To: Design Review Board  
From: Tony Leavitt, Senior Planner  
Date: November 10, 2016  
File No.: DRV16-01412  
Subject: VAREZE RESIDENTIAL PROJECT  
DESIGN RESPONSE CONFERENCE

# VAREZE RESIDENTIAL PROJECT DESIGN REVIEW DRV16-01412

Design Review Response 11/7/16:  
materials and colors boards  
revised side elevations  
lighting concepts  
landscape plan updates

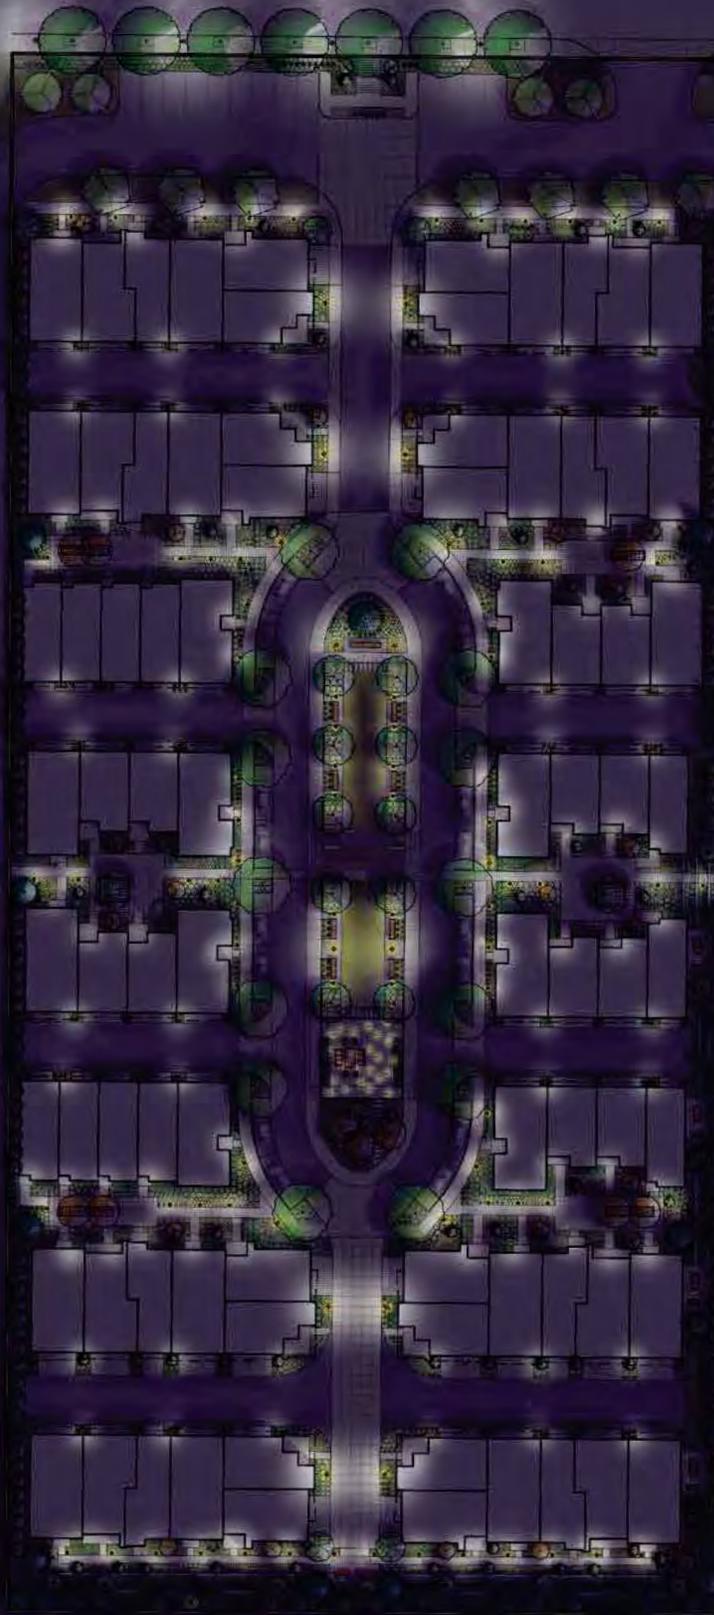
Would like to see  
a lighting plan  
along NE 116th, the  
Park, and building  
lighting.

This conceptual  
lighting concept  
highlights the intent  
of the project.  
The minimum  
foot candles will  
be provided per  
Code. All lighting  
will be shielded  
to prevent glare  
and unnecessary  
light pollution to  
neighbors.

lighting  
concept

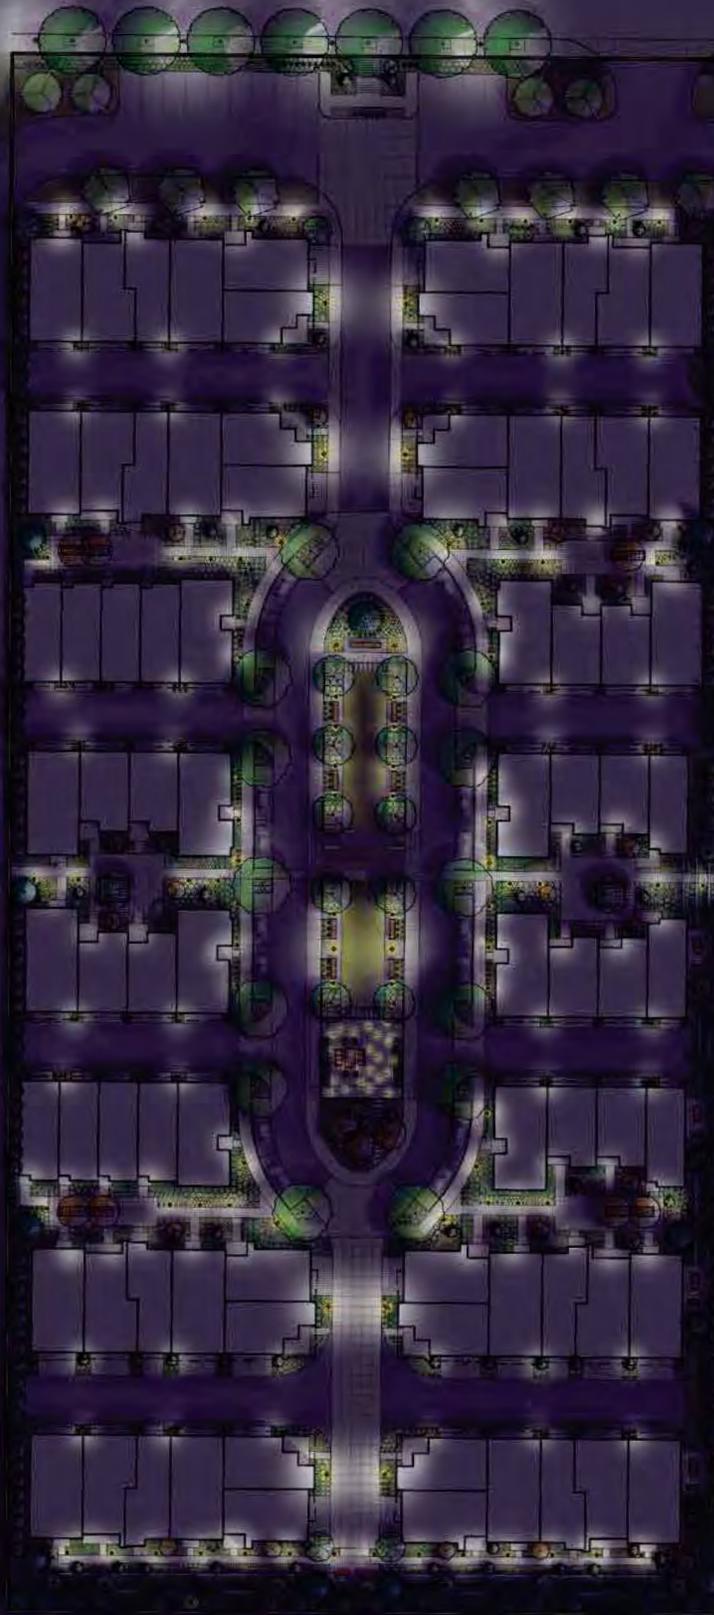
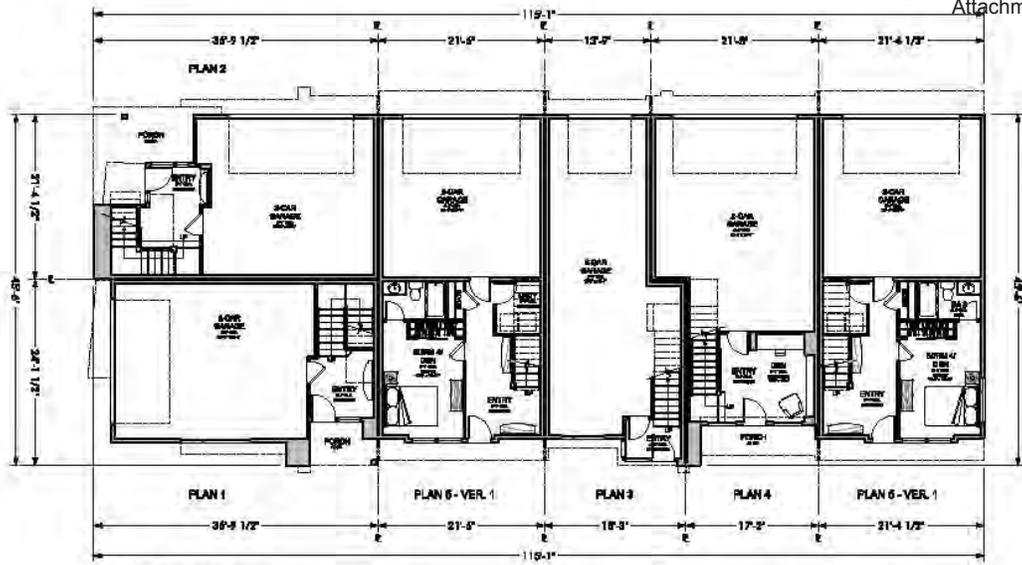
Would like to see a lighting plan along NE 116th, the Park, and building lighting.

This conceptual lighting concept highlights the intent of the project and is not a technical study. The minimum foot candles will be provided per Code. All lighting will be shielded to prevent glare and unnecessary light pollution to neighbors.
